APPEAL SUMMARY

Status: Decision Rendered - Reconsideration of ID 26490

Appeal ID: 27522	Project Address: 12005 N Burgard Rd
Hearing Date: 2/16/22	Appellant Name: Kenny Dupuis
Case No.: B-011	Appellant Phone: 5036438595
Appeal Type: Building	Plans Examiner/Inspector: Geoff Harker
Project Type: commercial	Stories: 1 Occupancy: F-2 Construction Type: II-B
Building/Business Name: Schnitzer L3DS Building	Fire Sprinklers: No
Appeal Involves: Erection of a new structure, Reconsideration of appeal	LUR or Permit Application No.: 21-081428-CO
Plan Submitted Option: pdf [File 1]	Proposed use: Equipment enclosure

SCHNITZER STEEL INDUSTRIES
PORTLAND FACILITY
METAL RECOVERY SYSTEM UPGRADE (3DS)

DWG. NO.
20-333B-106

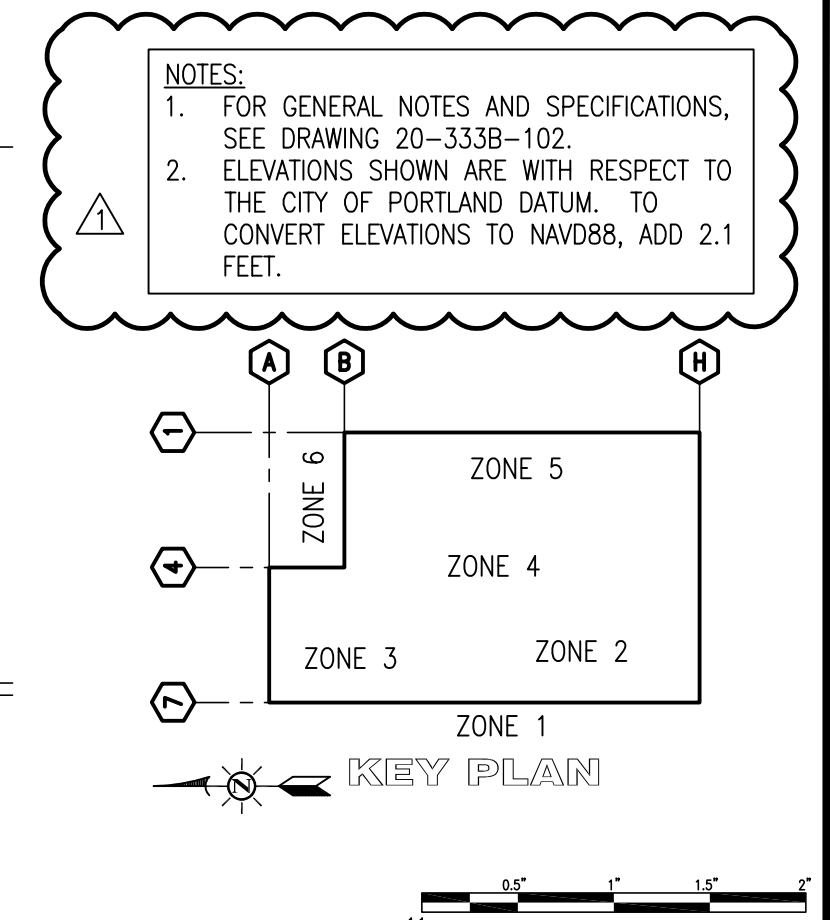
PLUMBING FACILITIES ARE PROVIDED IN BUILDING THE HEAVY MEDIA BUILDING A, REFERENCE PERMIT 20-218897-CO. SEE SMG DRAWING 106 AND BUILDING CODE APPEAL ID 26490, APPEAL ITEM 1.

SCALE	DWG. NO.	RI
AS NOTED	20-333B-110

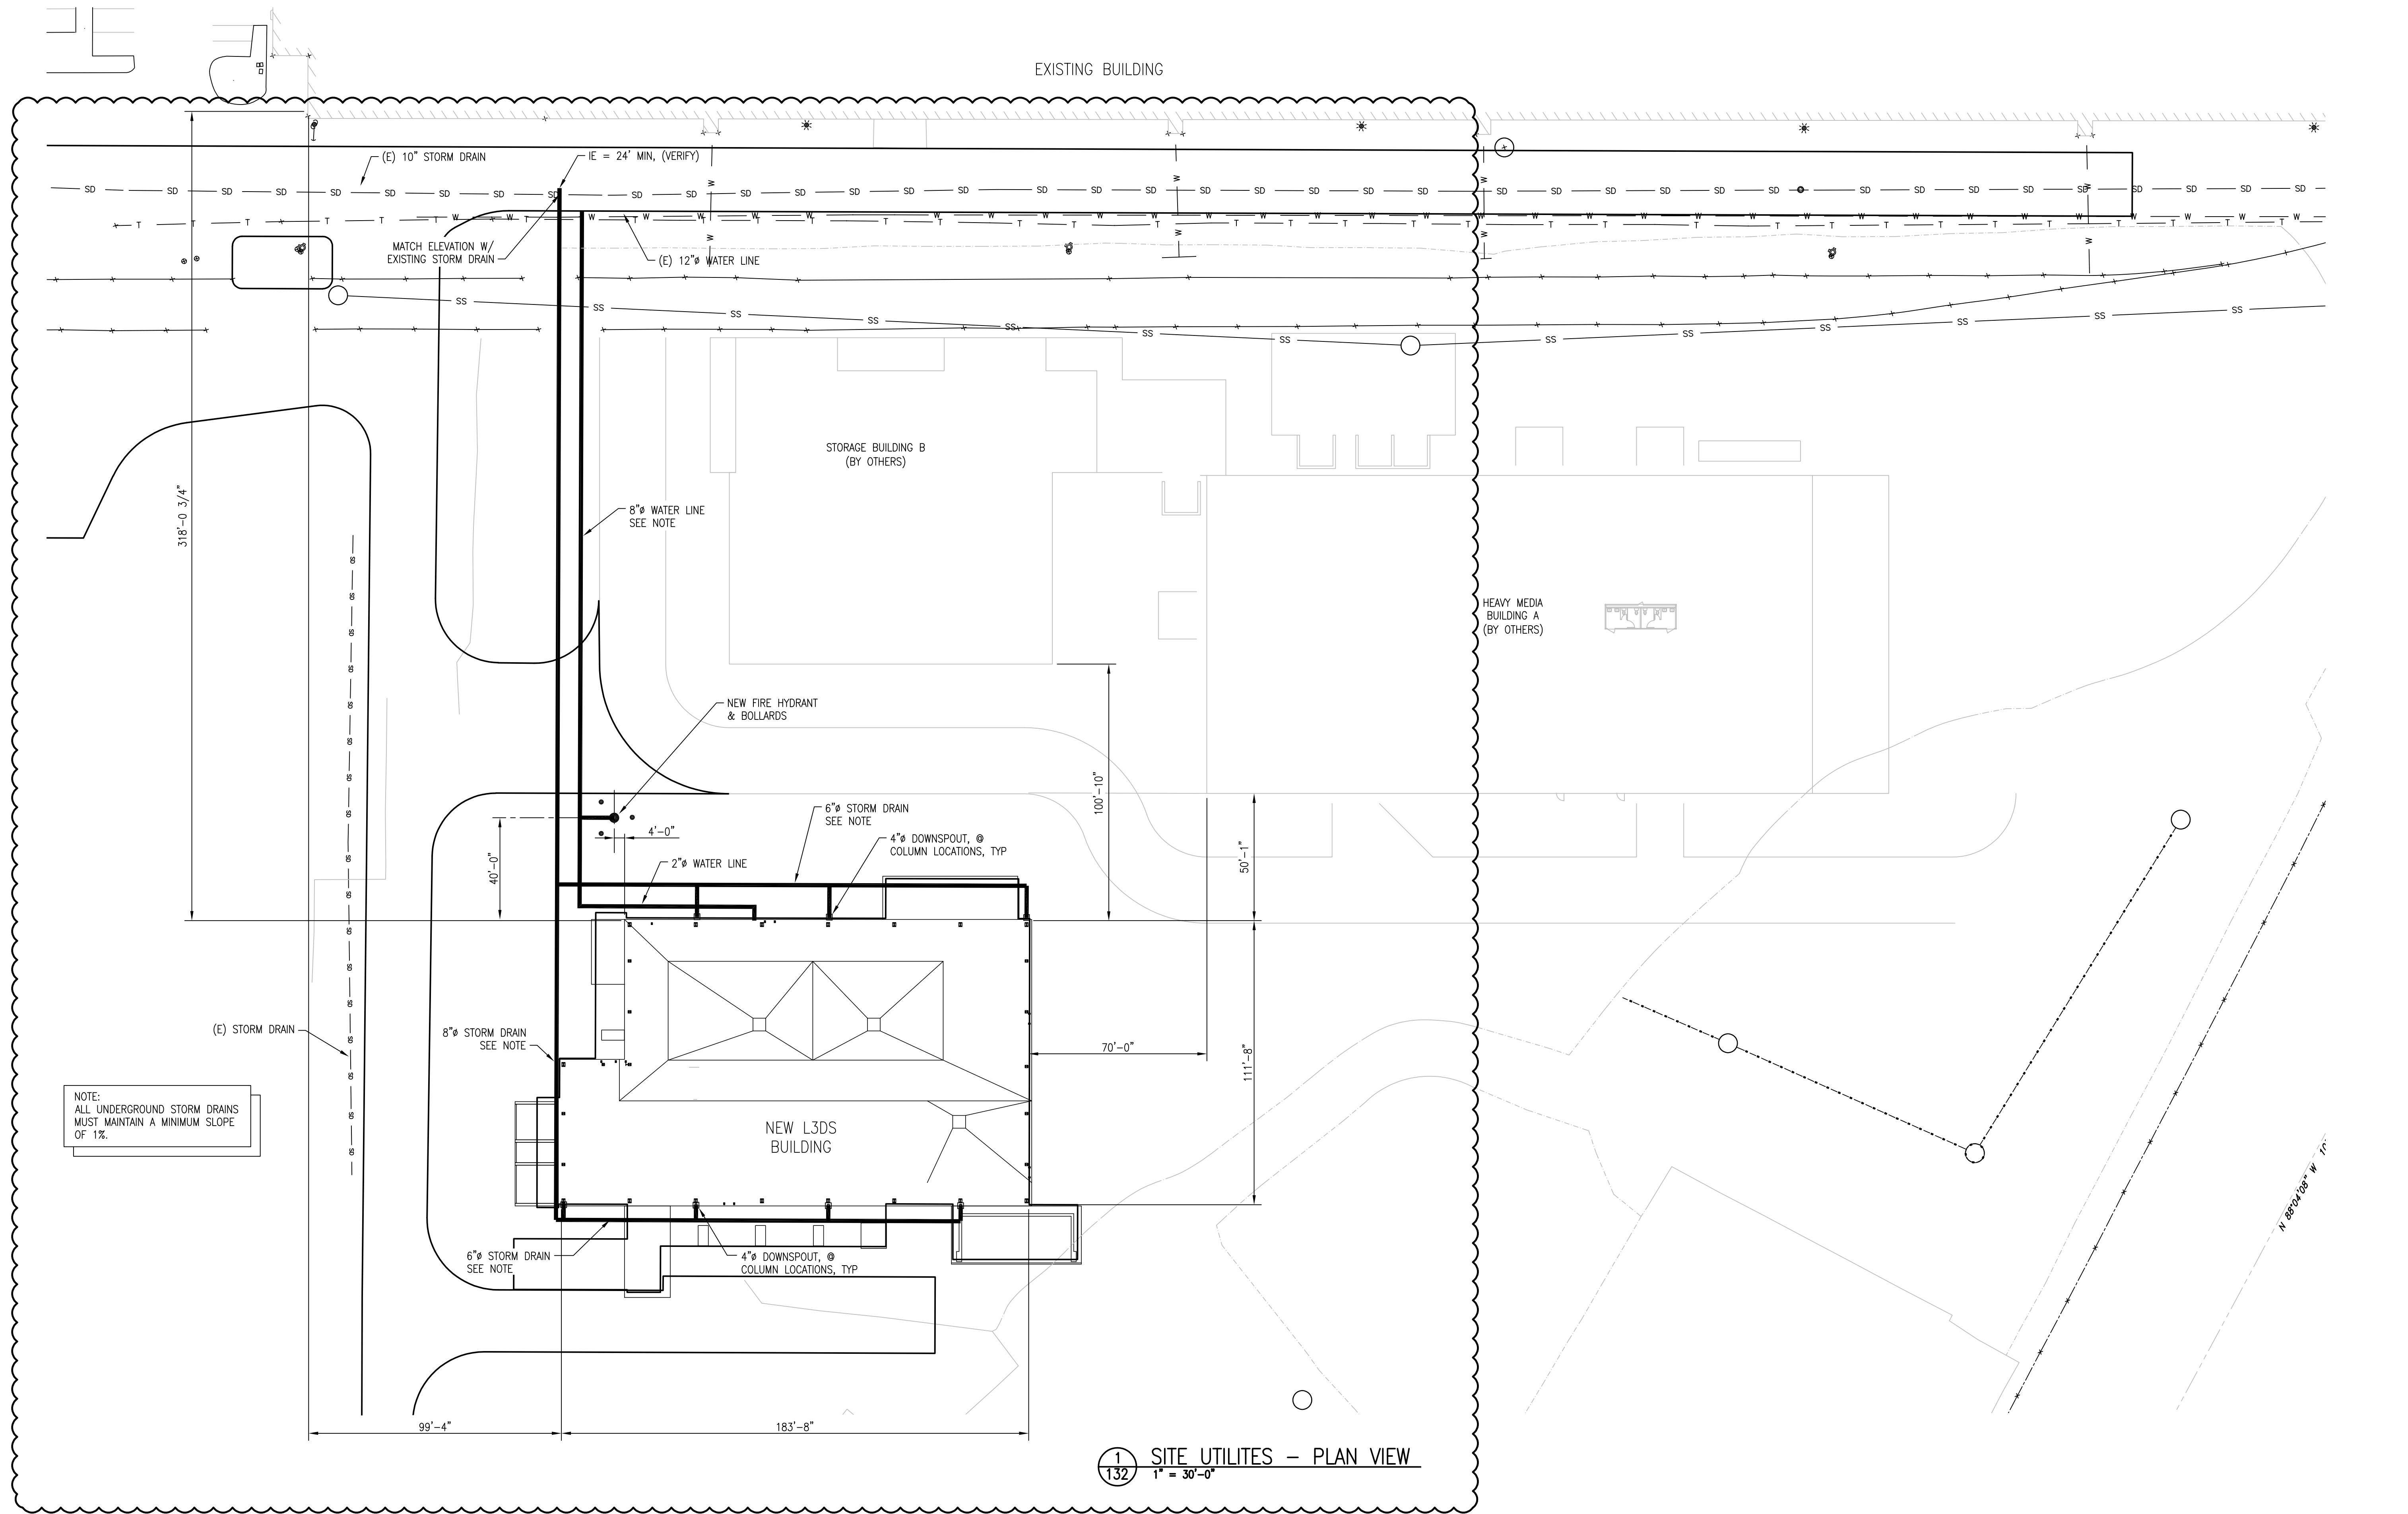
The 3DS building is primarily an enclosure for mixed metal sorting equipment, see drawing 20-333B-110. The equipment is comprised of conveyor belts, shakers, screens and water sorting pieces that do not require personnel to operate or function. In fact, the only reason for employees to be in the building is to perform maintenance and clean up functions. The building will be unconditioned (appeal #2 approved) and is currently proposed with no sanitary sewer connections because sewer is needed for the sorting process.

Per Ch. 10 Table 1004.5, the occupant load for industrial areas is 1 per 100 gross sq ft of area, or 190 for the 19,000 sq ft 3DS building. In my opinion, this building is really more like a warehouse which would require 1 per 500 sq ft for an occupant load of 38. In fact, the owner forecasts needing only 7 employees per shift, to perform housekeeping and maintenance activities in the building. The difference between 7 and 190 employees is significant. We think that for the 7 employees working in the building, traveling about 270 feet exposed to the elements from 3DS door to Heavy Media door is adequate and matches up with the rest of the site layout, heavy industrial metal recycling. This facility is not an occupancy where workers are actively fabricating, assembling or processing materials, equipment performs this function.

Location of required toilet facilities to serve new 3DS building in separate heavy media building: Denied. Proposal does not provide equivalent sanitary protection. Appellant may contact John Butler (503 865-6427) or e-mail at John.Butler@portlandoregon.gov with questions.
